DATE: 26.02.2019

Subject- Corrigendum-12 for revision in technical specification, PQR, SLD, Layout, BOQ, mode of payment for foreign bidder and extension of due date

1. Project : TANGEDCO UDANGUDI STPP STAGE-1
2. Equipment / Item : 400KV GIS
3. Enquiry No. / Date : 278E041 , Dtd. 24/04/2018

DEPT. SCALE 1:300
SIGN
DRAWING NO. TB-1-400-316-001
SHEET 02 OF 02 REV. 03

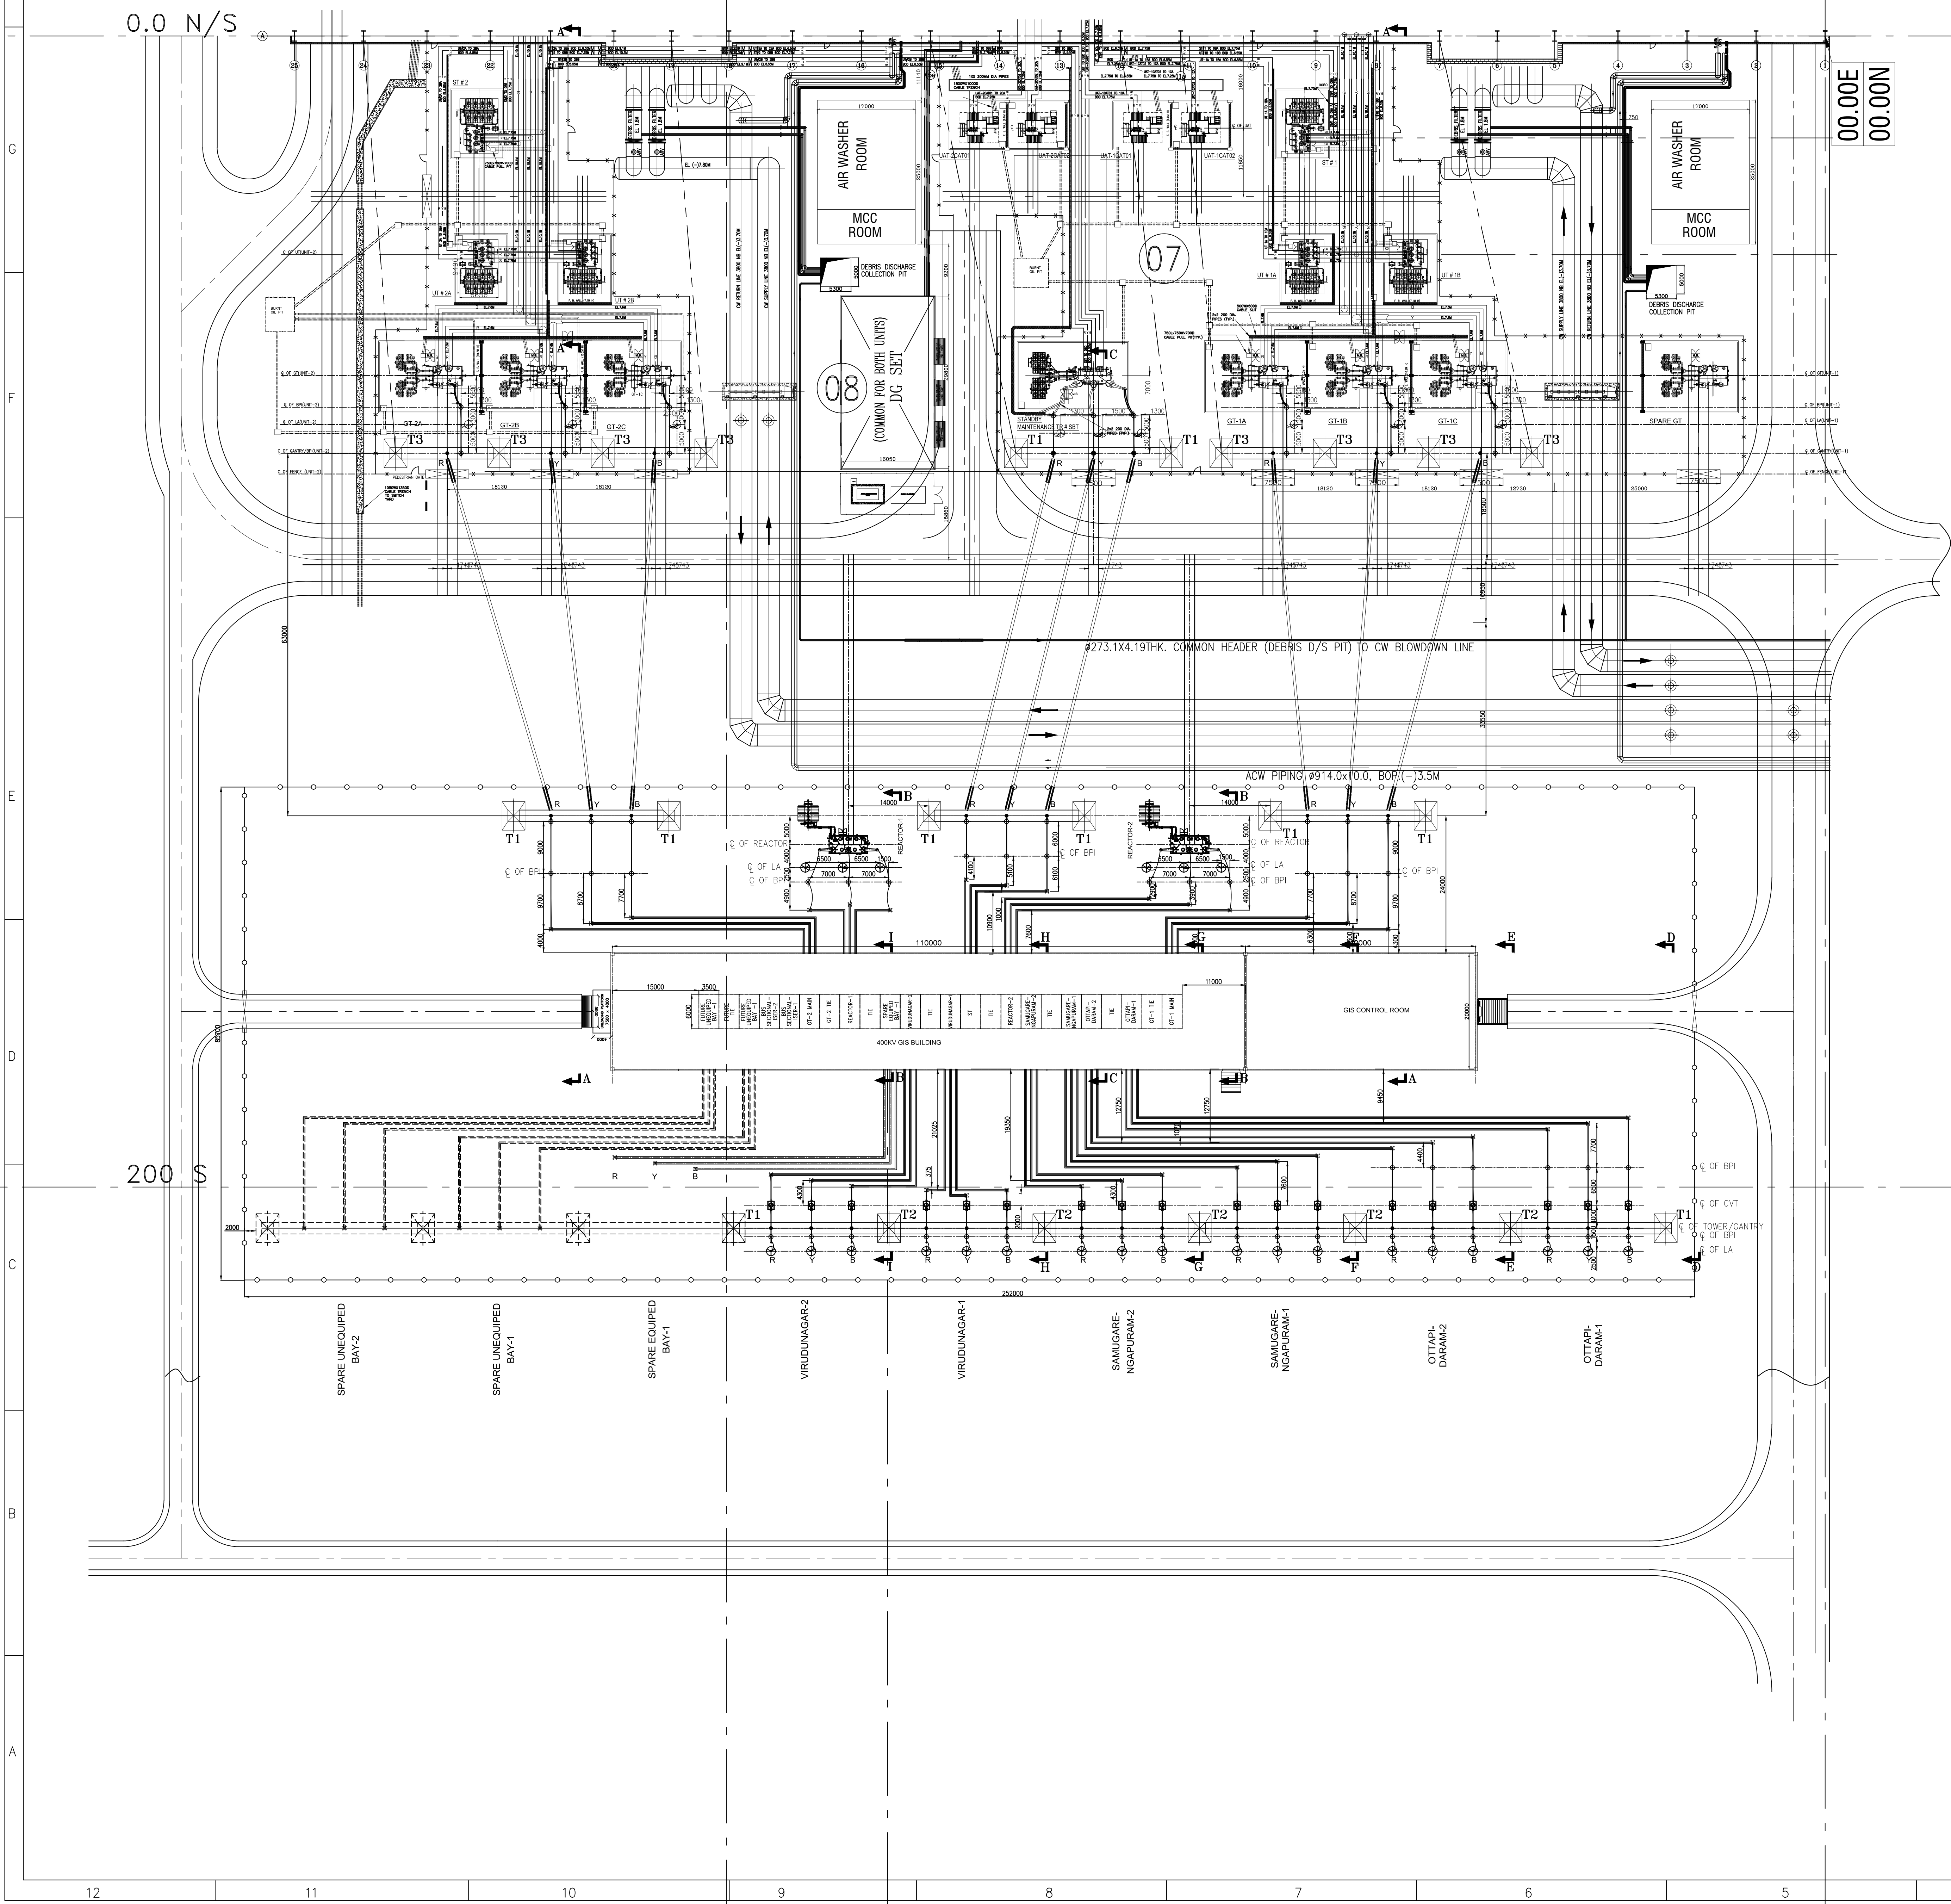
2. ALL DIMENSIONS ARE IN MM UNLESS OTHERWISE SPECIFIED.
3. THE FOLLOWING MINIMUM CLEARANCE ARE ADOPTED AS PER SPECIFICATION (FOR OUTDOOR SWITCHYARD)
CLEARANCE

a) Ph-Ph	4000
b) Ph-Earth	3500
c) SECTIONAL	6500
d) GROUND	8000
4. MINIMUM LEVEL OF BOTTOM OF ANY INSULATOR ABOVE GROUND LEVEL (FROM PLINTH) IS 2550 MM.
5. CONDUCTOR DETAILS:
FLEXIBLE CONDUCTOR (FOR 400KV, 2000A CONNECTION): ACSR TWIN LAPWING CONDUCTOR
RIGID CONDUCTOR (FOR 400KV, 2000A CONNECTION): 4" IPS (EH) ALUMINUM TUBE
6. FOR QUANTITIES AND DETAILS OF EQUIPMENTS PLEASE REFER SLD.
7. 400KV GIS BUILDING & GIS CONTROL ROOM BUILDING DIMENSIONS ARE TENTATIVE & SUBJECT TO CHANGE AS PER ACTUAL BUILDING DESIGN/LAYOUT DRAWING
8. SPARE EQUIPED BAY SCOPE IS UPTO GIS BUSHING
9. SPACE FOR SPARE UNEQUIPED BAYS TO BE PROVIDED IN GIS HALL & FOR BUST DUCT ROUTING IN OUTDOOR SWITCHYARD
